PLANS AND DOCUMENTS
referred to in the PDA
DEVELOPMENT APPROVAL

PROJECT
OLD PUB LANE, GREENBANK

SUBJECT
WATER RETICULATION SITE PLAN

SUBJECT
CONCEPT SITE SEWER PLAN

DRAWING No.
C0602

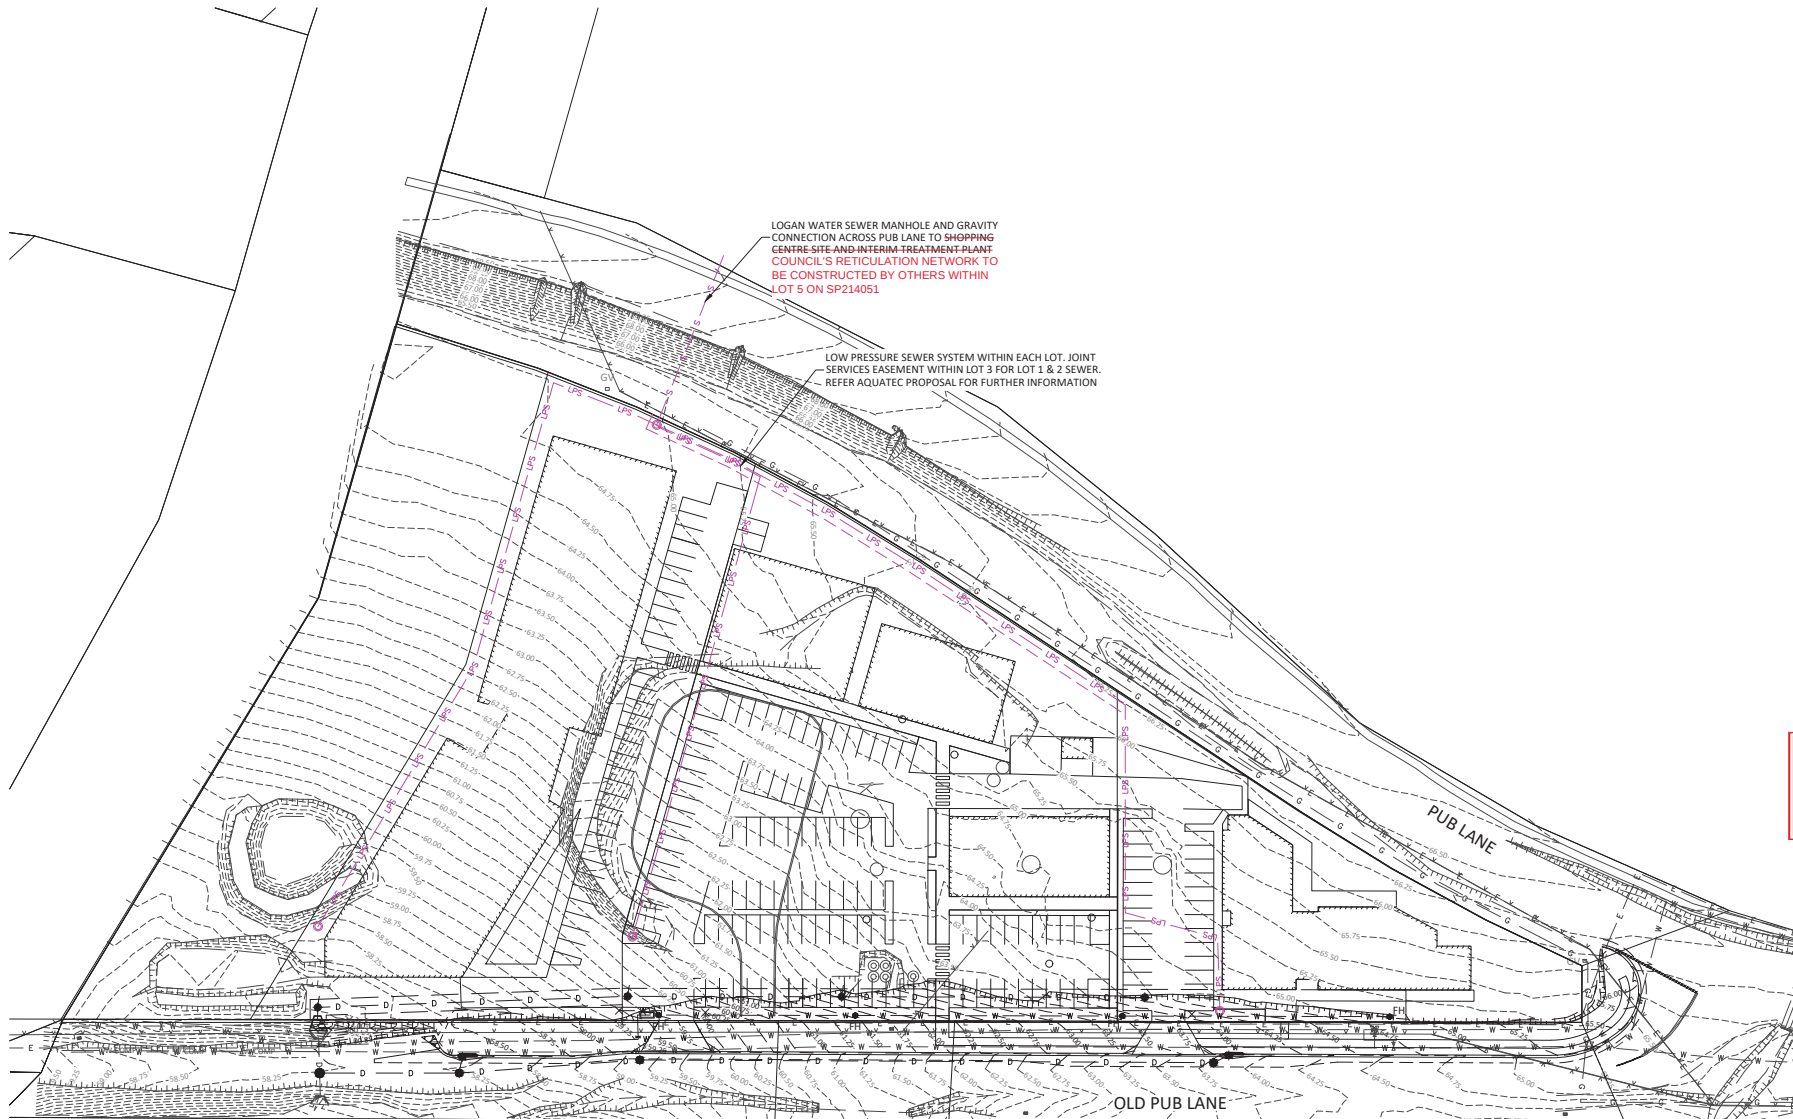
AMENDED IN RED

By: Anita Torbey Fuller
